SERVICE BULLETIN

ENGINE - POWER PLANT - FANCASE GENERAL SERVICES HARNESS - CONNECTOR BACKSHELLS - REPLACEMENT OF - CATEGORY CODE 4 - MOD.ENG-71-0038

V2500-ENG-71-0038

Location of the IDG Connectors on the Right Side of the Engine Fancase
Fig.1

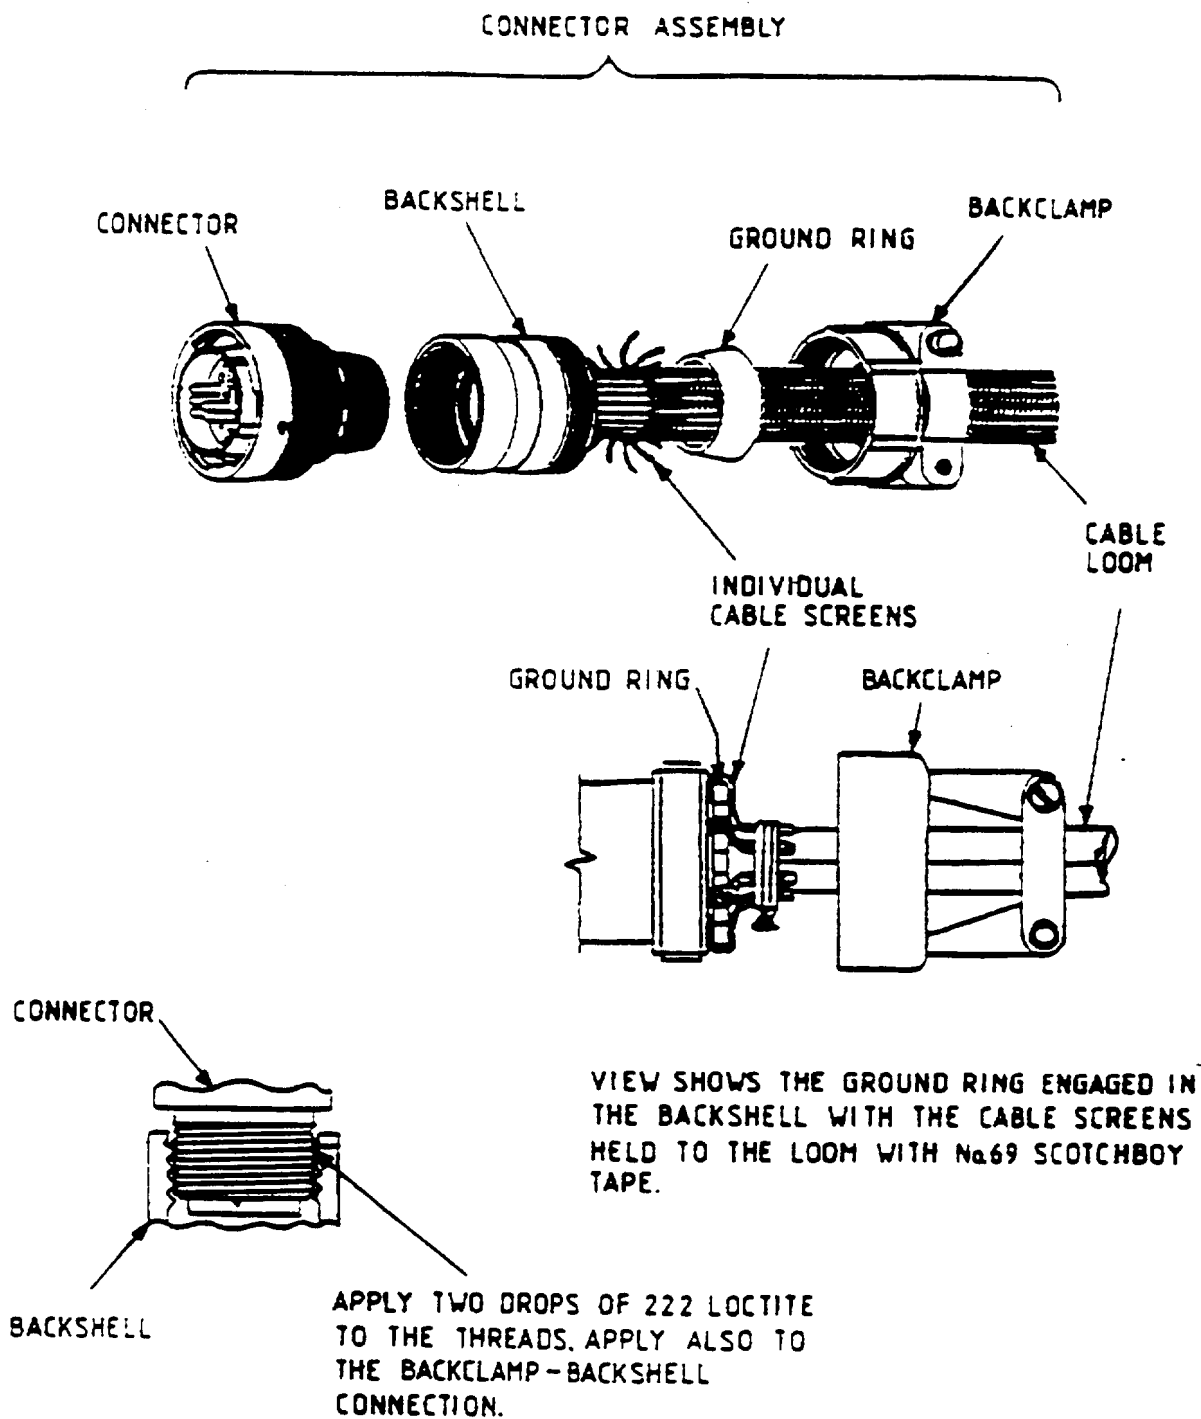
- (1) Open the fan cowl doors as specified in the V2500 Aircraft Maintenance Manual, Task 71-13-00-010-010.
- (2) Find the 4000xu-A and 4000xu-B connectors on the right side of the engine fan case at the integrated drive generator. (Refer to Figure 1.) Disconnect the connectors.

Insert Configuration for the 4000xu-A Connector
Fig.3

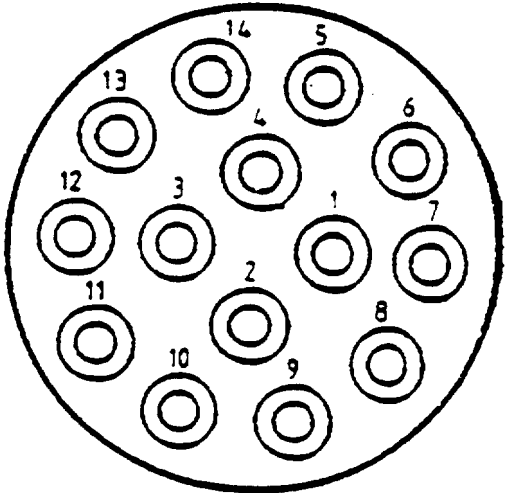
- (2) Replace the backshell as follows:
 - (a) Remove all the cables from the 4000xu-A connector with an M81969-14-02 insertion/removal tool. (Refer to Figure 3.)

- (b) Replace the 387AJ008M1808A backshell with a 388AJ101M1808A backshell on the cable loom.
 - (c) Install the cables back into the connector with an M81969-14-02 insertion/removal tool. (Refer to Figure 3.)

Insert Configuration for the 4000xu-B Connector
Fig.4

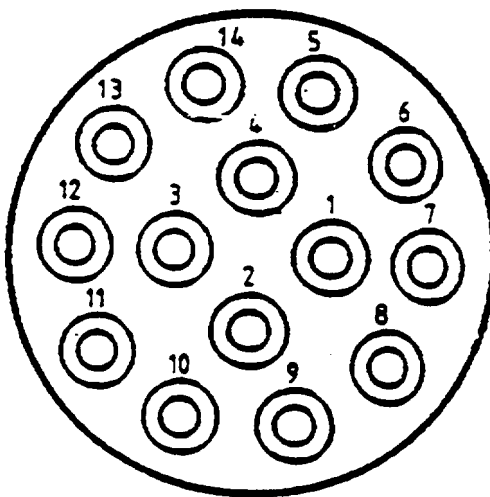
- (4) Replace the backshell on the 4000xu-B connector with instructions in paragraphs 2.B.(1) and 2.B.(2). (Refer to Figure 4.)
